CITY OF MOBILE
TIGER 2016 Project Phase Four- Dr. Martin Luther King Jr. Ave from NW of Butchers
Lane to Beauregard St
Project No. 2023-2045-01

ADDENDUM #2

This addendum includes the following: (1) revised contract language, (2) revised PROPOSAL form (Attachment "A"), (3) responses to remaining questions and (4) updated plan sheets (Attachment "C"). This addendum consists of a total of 93 pages, including the cover page.

SUMMARY OF PLAN SHEET CHANGES

REFERENCE PROJECT NO	FISCAL YEAR	SHEET NO
2023-2045-01 TIGER-FAUP- 4917(250)	2025	2F

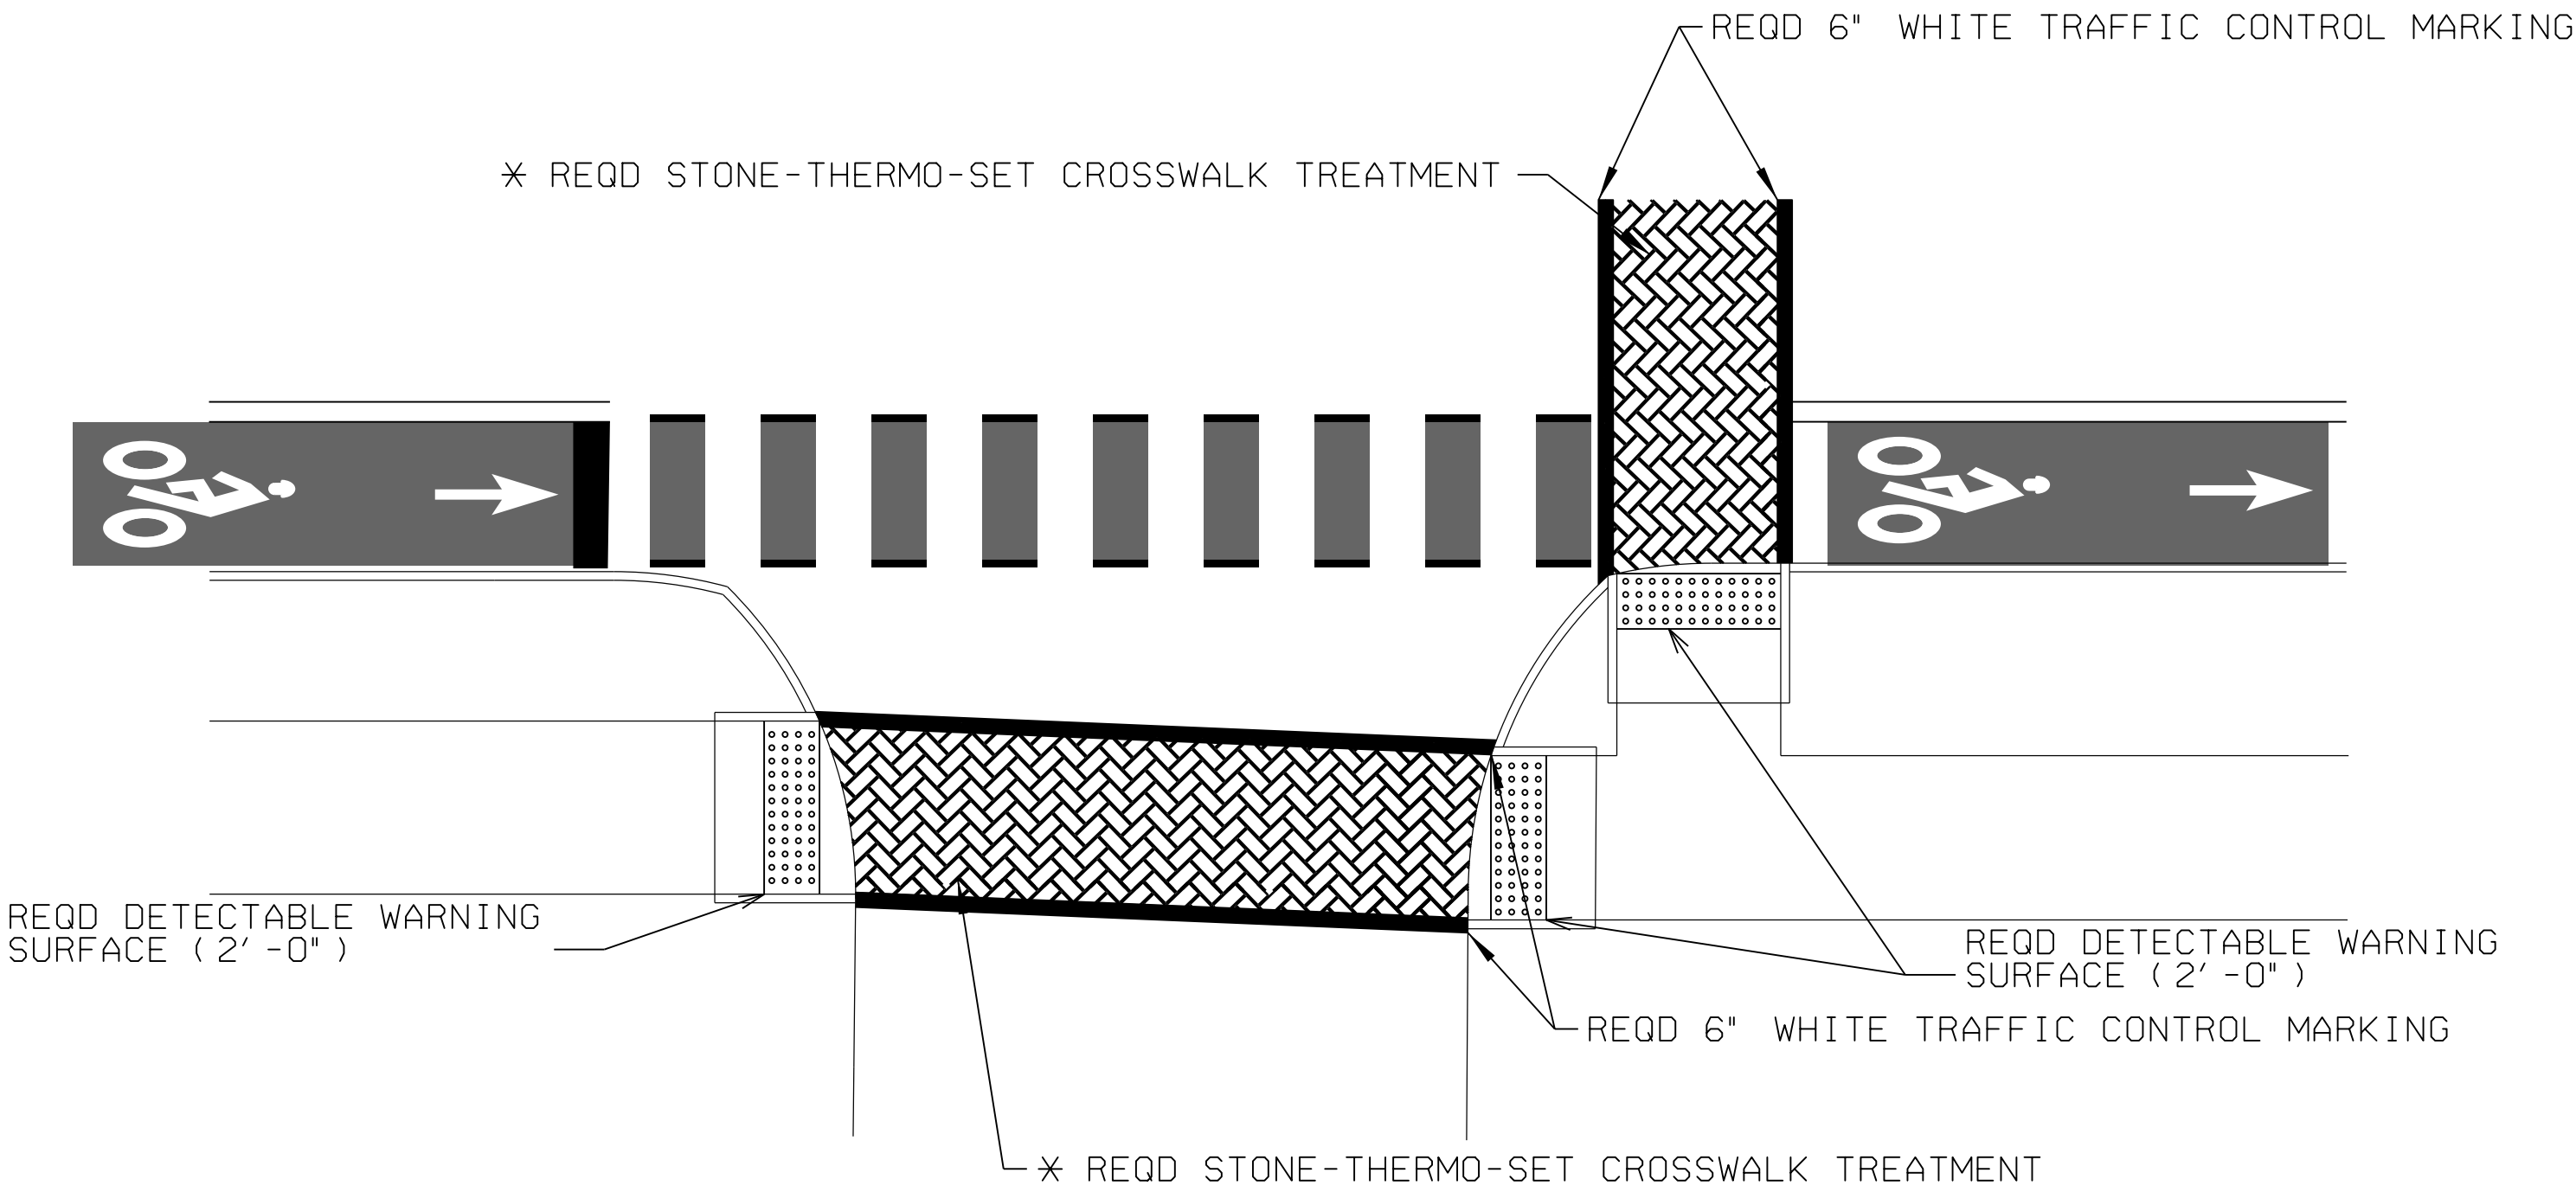
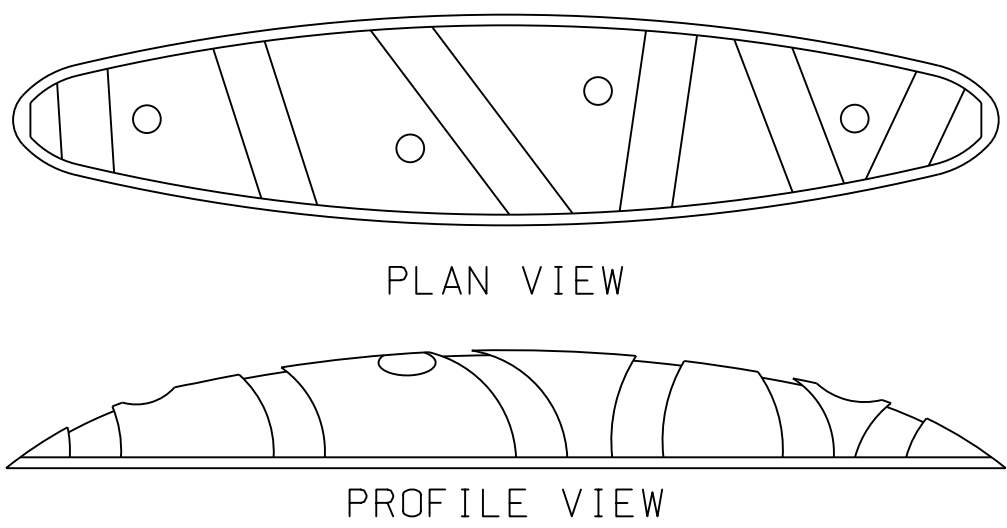
- **SHEET 1D**
 - Index No 75026 added.
- **SHEET 2F**
 - Reference to stone-thermo-set marking detail including locations at Cedar Ave and Live Oak St removed.
- **SHEET 2-O**
 - Reference to directional bar tile in Note 19 removed.
 - Adjustments in Note 37 clarified to read "Required connection of the new manhole frame and over to the existing manhole structure and necessary raising or lowering of the new manhole frame and cover to the resurfaced roadway elevation shall be subsidiary to 621E."
 - Note 41 added "Pay Item SP-005 WORK OF SIMILAR NATURE set up to cover work similar to bid items as directed by the engineer."
- **SHEET 3-3Q**

REFERENCE PROJECT NO	FISCAL YEAR	SHEET NO
2023-2045-01 TIGER-FAUP-4917(250)	2025	401

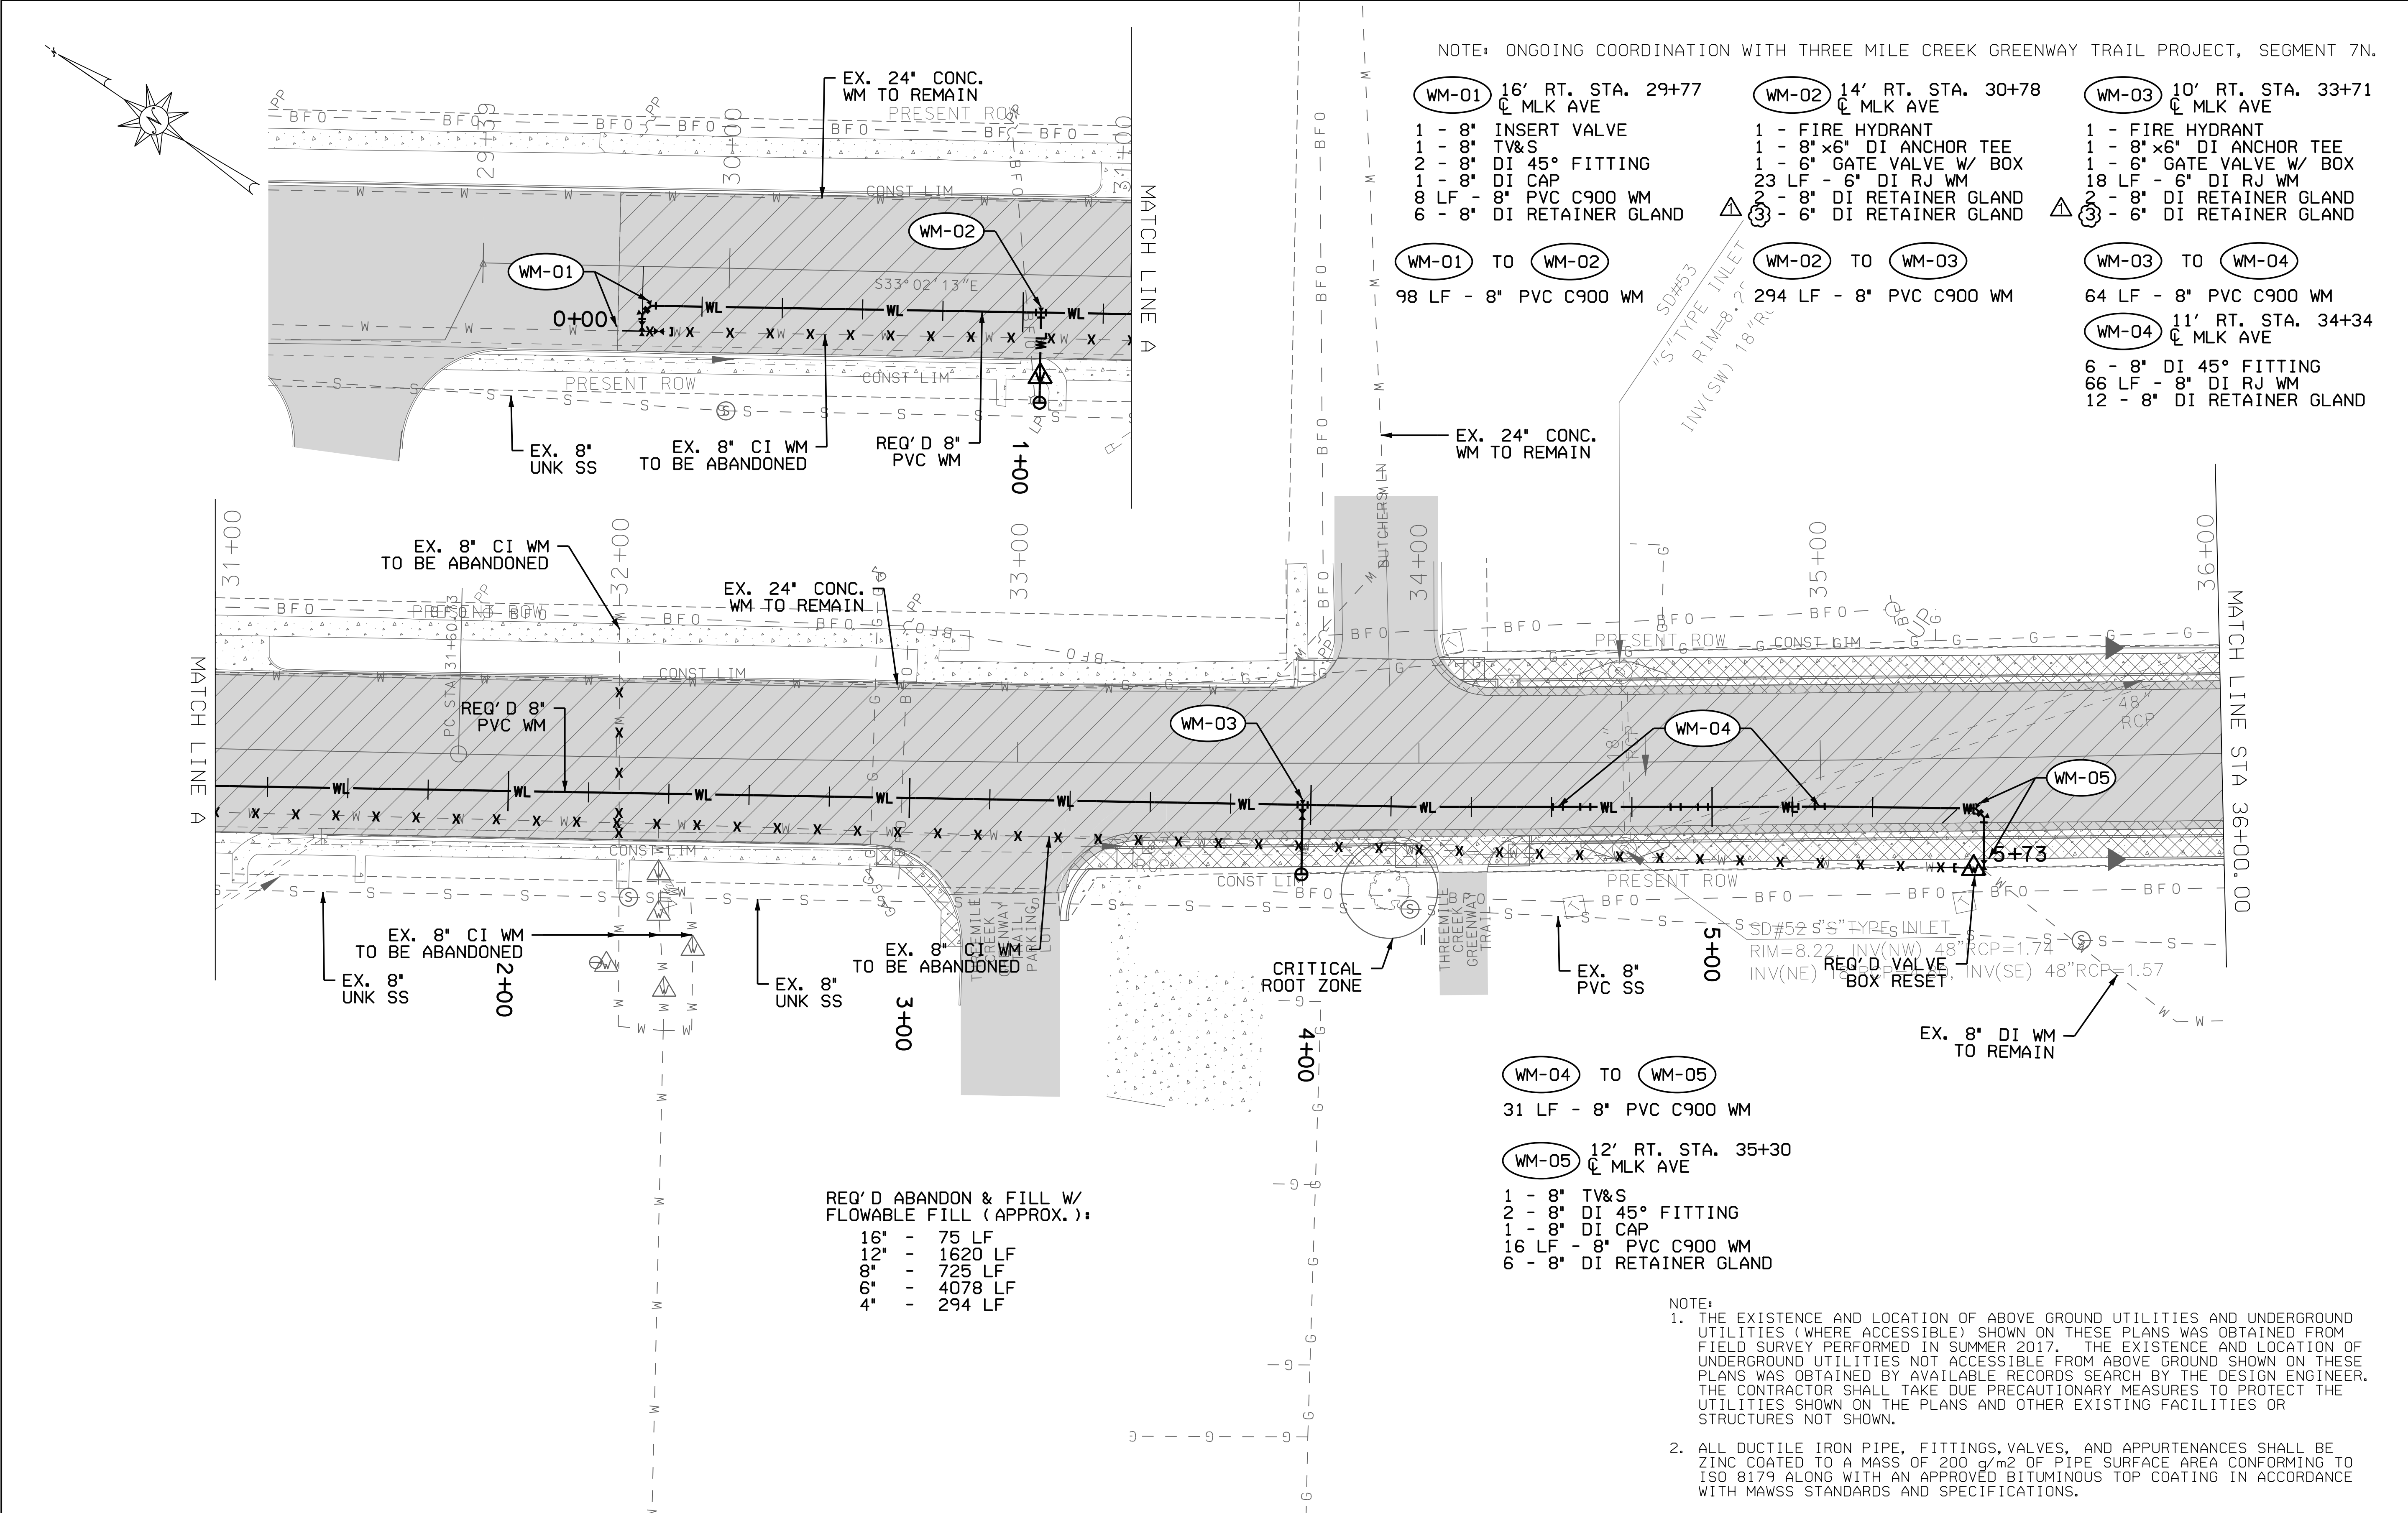
- Callouts WM-02 and WM-03 – Revised 6" retainer gland quantities
- **SHEET 401A**
 - Callout WM-05 – Modified leader arrows
- **SHEET 404**
 - Callout WM-11 – Added additional 6" gate valve, changed 8"x6" tee to 6"x6" tee, and revised retainer gland quantities
